1 CPTED SITE PLAN
3/32" = 1'-0"

PZ23-12000055

PROPOSED WAREHOUSE FOR:
REGANZANI GROUP LLC
VACANT PROPERTY, SW 3RD STREET,
POMPANO BEACH, FL, 33069

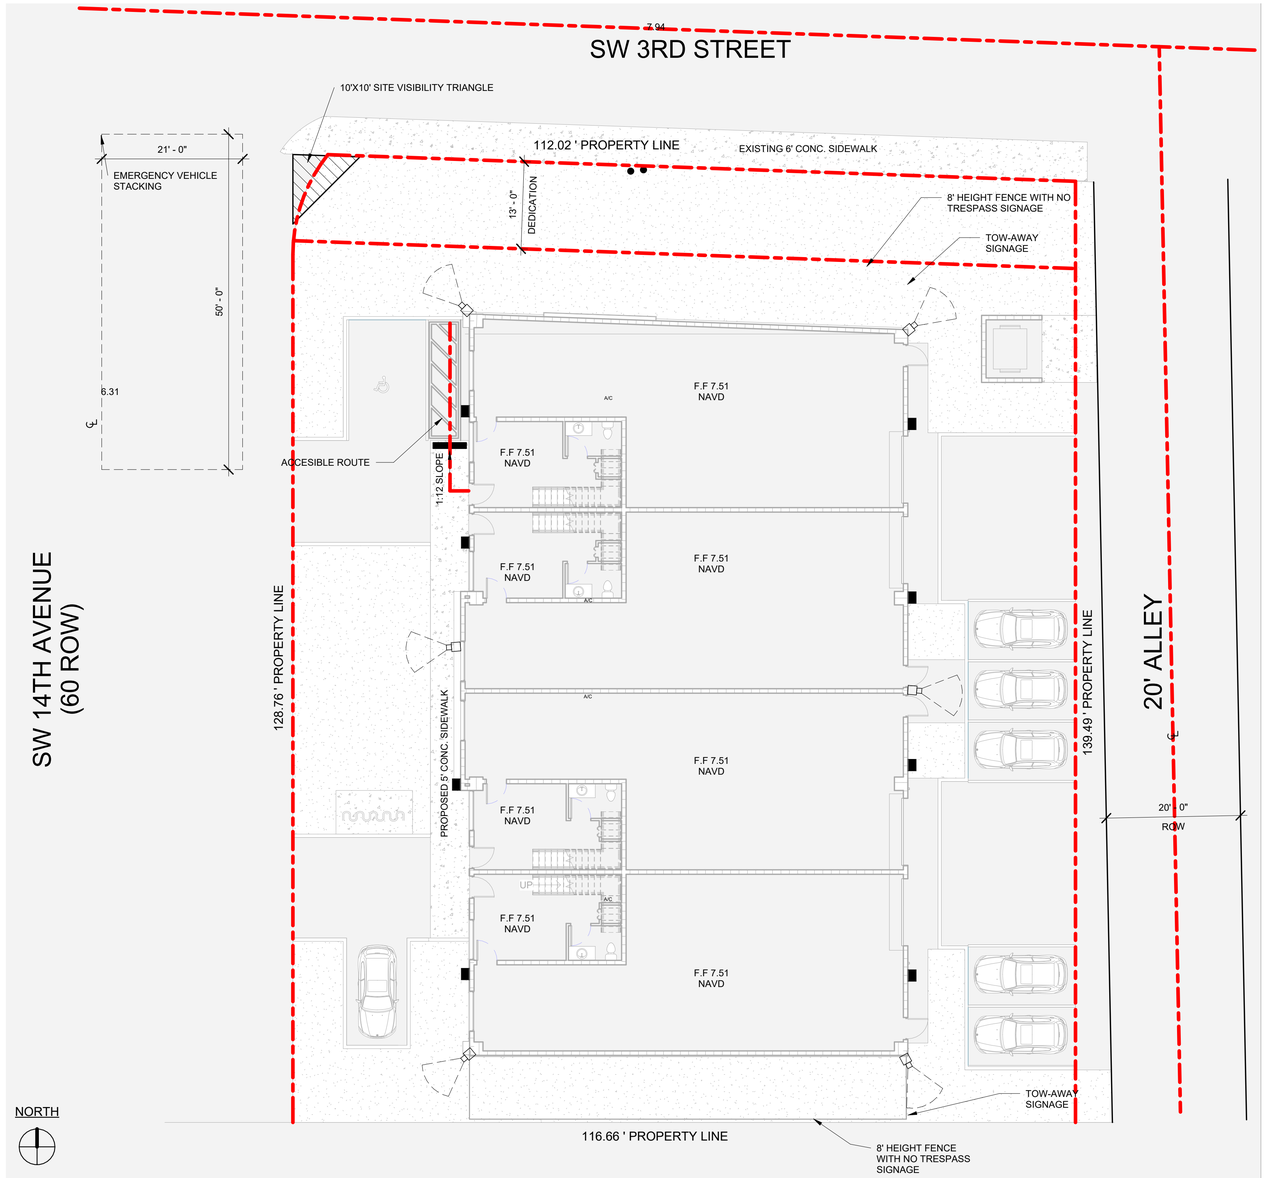
A. Natural Surveillance (Landscaping)
1. Tree canopies should not be lower than 8ft in height. .(Note that young immature trees with 6" inch or less diameter trunks are excluded from this condition ONLY WHILE MATURING per code.)

1. Designated ADA access ramps (if any) are to utilize see through fence railing for improved natural surveillance.

A1. Electronic Surveillance - Security Strengthening
*** ATTENTION ***
PROPOSED CAMERA AND MONITORING LOCATIONS WILL BE COORDINATED WITH A SECURITY AND ACCESS CONTROL CONSULTANT AND THE BROWARD SHERIFF 'S OFFICE CPTED REVIEWER *** PRIOR *** TO PERMITTING. PLANNING AND INSTALLATION OF THE SURVEILLANCE MONITORING SYSTEM MUST INCLUDE FIELD INPUT FROM EXPERIENCED CPTED/ SECURITY STRENGTHENING LAW-ENFORCEMENT TO ENSURE OPTIMAL RESULTS.
Will Comply
1.) Surveillance Monitors depicting real time security camera views must be strategically located for maximum overlapping active and passive observation.
Will Comply

1.) Install hard-wired burglar security alarms, or at the minimum prewire each unassigned / vacant warehouse bay.
Will Comply
2.) Perimeter Fencing
(Please clarify: The CPTED Narrative states 6' high fencing around the building & the CPTED Diagram states 8' fence indicated at the north & south side of the building. If the fence goes completely around the building, please describe the access control method i.e., manual, electronic, rolling or swing gates, etc.)
Will Comply

1.). A robust locking mechanism such as a throw bolt with a robust shielded padlock for example rather than only a vulnerable chain and non-shielded padlock.
Will Comply
2.) Bottom gate clearances must be 8" above the ground. Purpose: For viewing underneath to deter loitering and trespassing inside the enclosures, and to deter/ prevent the enclosure from being used as concealment/ ambush for a more serious crime such as a violent robbery, sexual assault/ battery, etc.
Will Comply
3.) If there is a pedestrian passageway into the dumpster enclosure it must have the lockable gate which remains closed and locked except when in active use by authorized persons.
Will Comply
4.) Enclosed trash rooms (if any) must be equipped with either constant lighting &/or a secured motion sensor lighting system that will provide immediate illumination upon entry.
Will Comply

1. Submit a Broward Sheriff's Office No Trespass Program Affidavit.
Will Comply
2. Post sufficient "Broward Sheriff's Office No Trespass" signage so that it is readily available at all entrances and all sides of the property: North, South, East, and West. Please note additional signage may be necessary depending on the size & layout of your development.
Will Comply

3. Post BSO No Trespass signs prominently with bottom edge of sign at approximately a minimum of 6' to 7' feet inheight from ground level for clear unobstructed viewing throughout property and from the site perimeter lines. Secure robustly using sturdy fasteners at all corners to help prevent vandalism.
Will Comply

1. Exterior wall surfaces along the building perimeter must be treated with a graffiti resistant resin up to 8 feet to prevent vandalism.
Will Comply
2. All publicly accessible exterior electrical power outlets must have a lockable metal cover AND easily accessible secure internal cutoff switch.
Will Comply
